# Access Compliance Report

## Public Rights-of-Way

### (Curb Ramps)

Intersection ID: 13404	Main Street: LEXINGTON_AV	Cross Street: E_CARSON_BV	Location: SW
ADA ID: 2BE386901E18	Ramp Type: Perp	Initial Pass/Fail: Fail	Overall Compliance: No
Codes/Mitigation Info/Possible Solution			Severity Score: 25
			Field Measurements/Component Compliance

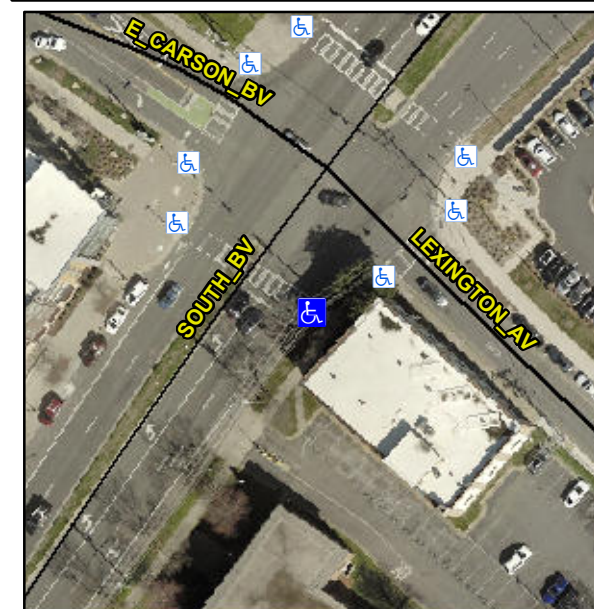
**Not Found, R304.2.2**

Compliance	Description	Data	Compliance	Description	Data
N/A	Ramp Length (in)	94.0	No	Ramp Slope (%)	13.7
Yes	Ramp Width (in)	48.0	Yes	Ramp XSlope (%)	0.7
N/A	Flare Type LT	N/A	N/A	Flare Type RT	N/A
N/A	Flare Slope LT (%)	N/A	N/A	Flare Slope RT (%)	N/A
N/A	Flare Traversable LT?	N/A	N/A	Flare Traversable RT?	N/A
N/A	Landing Length (in)	N/A	N/A	DWS Provided?	N/A
N/A	Landing Width (in)	N/A	N/A	DWS Contrast?	N/A
N/A	Landing Slope (%)	N/A	N/A	DWS Length (in)	N/A
N/A	Landing X Slope (%)	N/A	N/A	DWS Full Width?	N/A
N/A	Landing Curb? (Y/N)	N/A	N/A	DWS Offset (in)	N/A
N/A	Shared Landing?	N/A			
N/A	Gutter Ponding?	N/A	N/A	Gutter Slope (%)	N/A
N/A	Gutter Lip Ht (in)	N/A	N/A	Gutter X Slope (%)	N/A
N/A	Painted X Walk1?	Yes	N/A	Painted X Walk2?	N/A
	X Walk 1 Direction	To NW		X Walk 2 Direction	N/A
N/A	X Walk 1 Width (in)	110.0	N/A	X Walk 2 Width (in)	N/A
	X Walk 1 Slope (%)	3.1		X Walk 2 Slope (%)	N/A
	X Walk 1 X Slope (%)	0.5		X Walk 2 X Slope (%)	N/A

**Remove & Replace Entire Ramp.**
